HISTORIC AND DESIGN REVIEW COMMISSION

HDRC CASE NO: 2021-020
ADDRESS: 231 W AGARITA AVE
LEGAL DESCRIPTION: NCB 3261 BLK 7 LOT 8 & W 20 FT OF 9
ZONING: R-5, H
CITY COUNCIL DIST.: 1
DISTRICT: Monte Vista Historic District
APPLICANT: Gregory Papay/PAPAY GREGORY S & EVA
OWNER: Gregory Papay/PAPAY GREGORY S & EVA
TYPE OF WORK: Roof replacement, gutter replacement, remove rear dormers
APPLICATION RECEIVED: January 12, 2021
60-DAY REVIEW: Not applicable due to City Council Emergency Orders
CASE MANAGER: Rachel Rettaliata

The applicant is requesting a Certificate of Appropriateness for approval to:

1. Replace the existing asphalt shingle roof with a standing seam metal roof
2. Remove the non-original dormers at the north (rear) side of the house to restore the simple hip profile to the roof.

ROOF PLAN

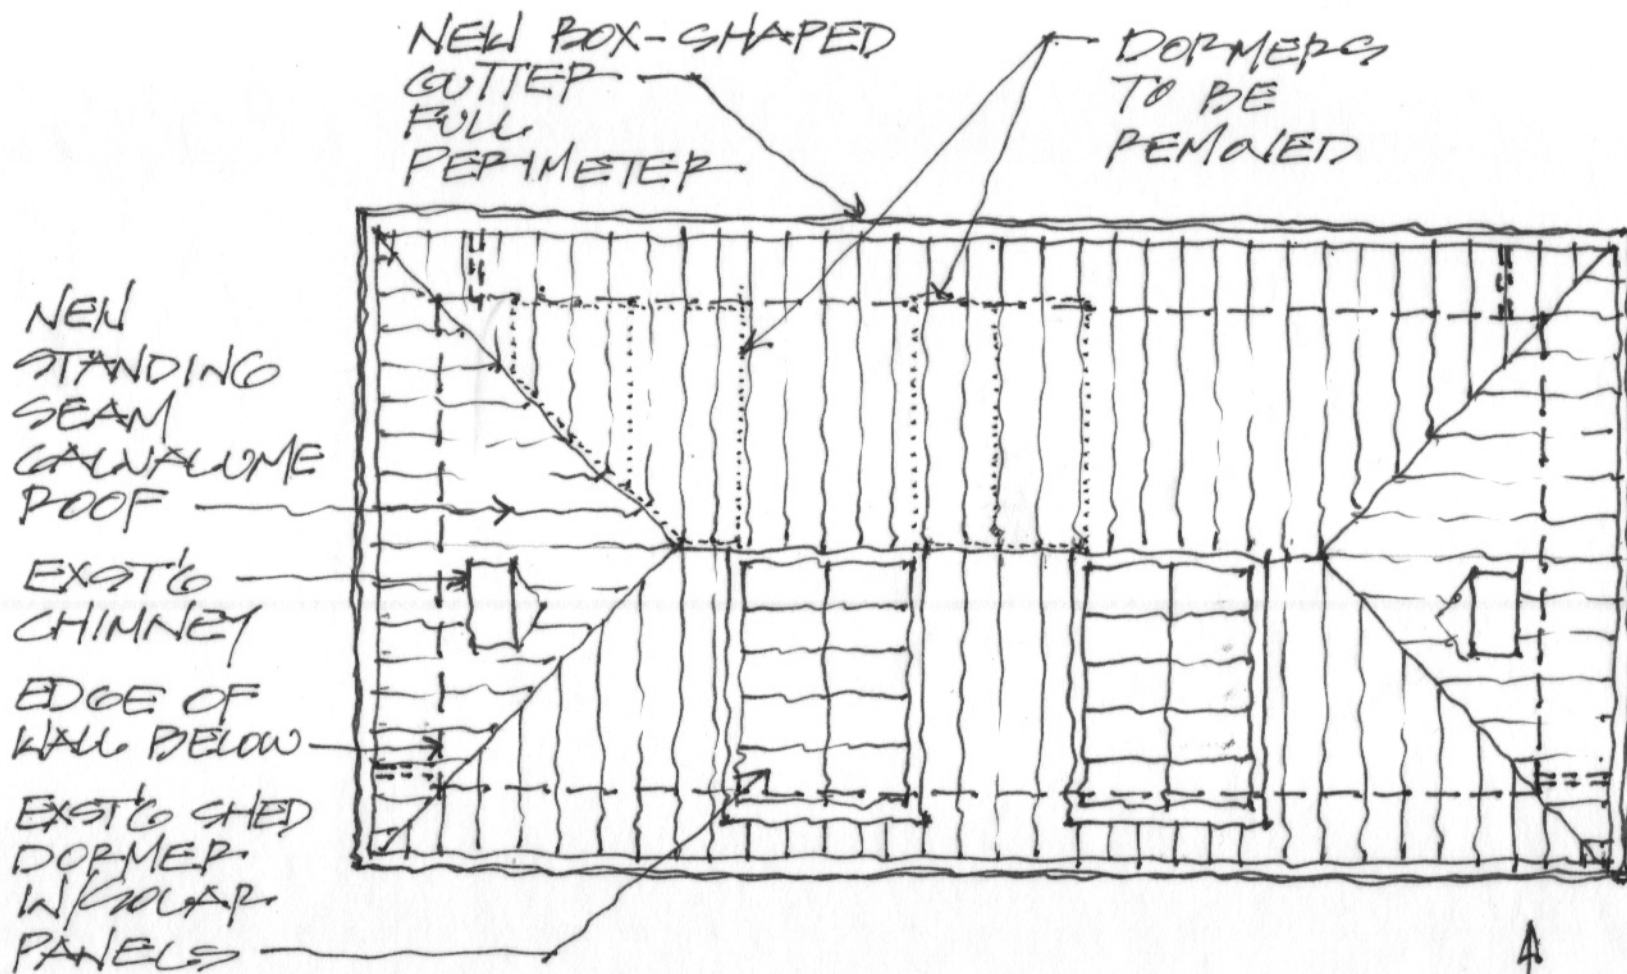
- b. ROOF REPLACEMENT – The applicant is requesting approval to replace the existing asphalt shingle roof with a standing seam metal roof with galvalume finish to match the existing roofing of the carriage house. The applicant has proposed to install a standing seam metal roof with a double-munch ridge configuration. According to Guideline 3.B.iv for Exterior Maintenance and Alterations, metal roofs can be used on structures that historically had a metal roof or where a metal roof is appropriate for the style of the construction period. According to the 1951 Sanborn map, the structure originally featured a roof covering of metal, slate, tile, or asbestos shingles. Staff finds the proposal appropriate.

Item 1, staff recommends approval of the request to replace the existing roof with a standing seam metal roof based on finding b with the following stipulation:

- i. That the applicant installs a standing seam metal roof featuring panels that are 18 to 21 inches wide, seams that are 1 to 2 inches high, a crimped ridge seam, and a standard galvalume finish. Ridges are to feature a double-munch or crimped ridge configuration; no vented ridge caps or end caps are allowed. An on-site inspection must be scheduled with OHP staff prior to the start of work to verify that the roofing material matches the approved specifications. All chimney, flue, and related existing roof details must be preserved.

NORTH ELEVATION - DEMO
231 WEST AGARITA

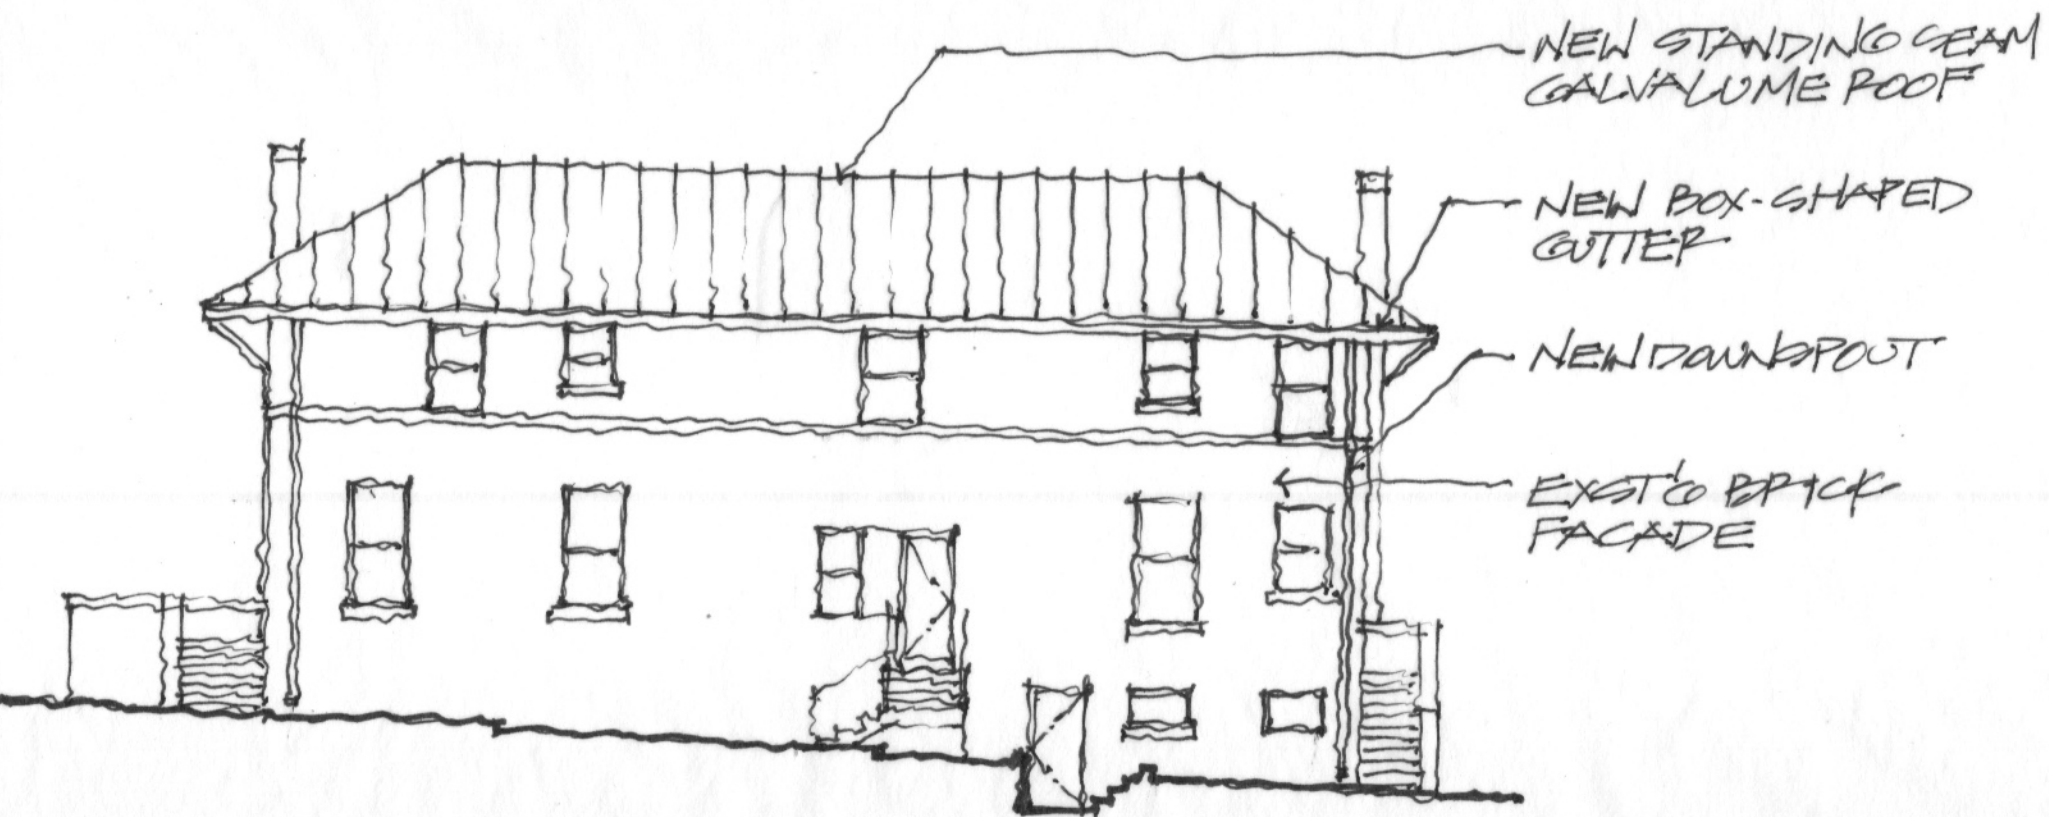
- c. DORMER REMOVAL – The applicant has proposed to remove the gable dormers located on the north side (rear) of the roof in order to restore the simple hip roof profile of the roof. Guideline 3.B.ii for Exterior Maintenance and Alterations stipulates that the original shape, line, pitch, and overhang of historic roofs should be preserved when replacement is necessary. The existing dormers are likely non-original elements and removing the dormer would preserve the original roof form. Staff finds the proposal appropriate.

Item 2, staff recommends approval of the rear dormer removal based on finding c.
